文件编号 Document No.	ESP-07-2-007-03	文件名称 Document Name	产品/工艺变更通知 Product/Process Change Notice (PCN)
文件版本 Document Version	1.4	保存期限 Retention Period	5 年 5 years

乐鑫 ESP32-C2 (ESP8684) 系列产品升级
Upgrade of ESP32-C2 (ESP8684) Series Products

PCN 编号 PCN No.	PCN20250101	提出日期 Issue Date of PCN	2025/01/24
变更日期 Proposed Date of Change	2025/03/24	预计变更后产品首次 出货日期 Proposed Date of First Shipment After Change	2025/04/24
PCN 类型 / PCN Category	<input checked="" type="checkbox"/> 客户需要批准/ Customer Approval Required <input type="checkbox"/> 客户通知/ Customer Notification

8. 给使用者的验证建议/ Verification Suggestion To Users

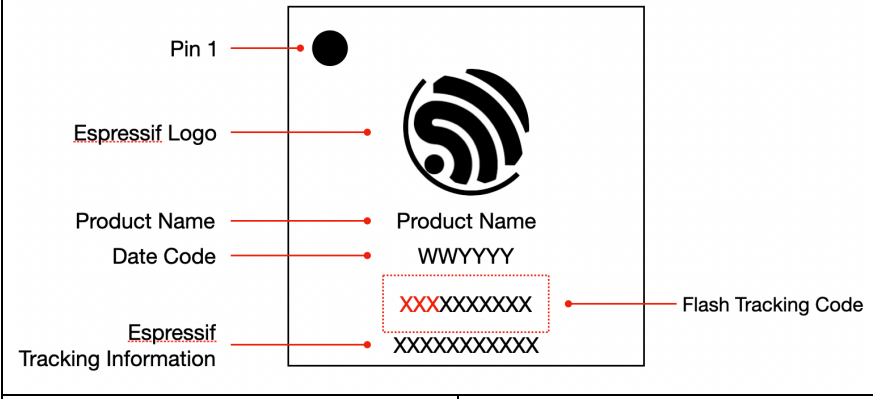
请确认您是否使用 flash 自动暂停功能，如有，请联系乐鑫。

在使用变更后产品前，请确保您的软件已升级至符合要求版本或更高版本的 ESP-IDF。

Please contact Espressif if you need the flash auto-suspend feature.

Before using the updated product, ensure that your software has been updated to the required version or above of ESP-IDF.
